IMPORTANT SAFETY RECALL

NHTSA Recall No. 23V-703

SN723

SUBJECT: Pedestal Mounting Bolts

Figure 1. Area of unit to inspect pedestal to sub-base mounting bolts

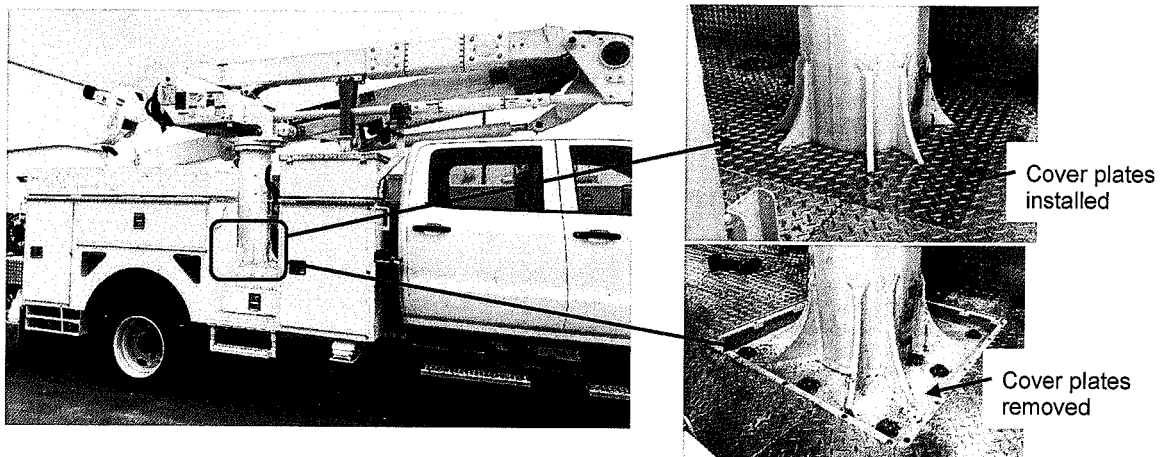
1. Immediately inform all users, operators, and supervisors that the pedestal to sub-base mounting bolts must be inspected before further use. Cover plates at the base of the pedestal may need to be removed to inspect the bolts, refer to Figure 1.
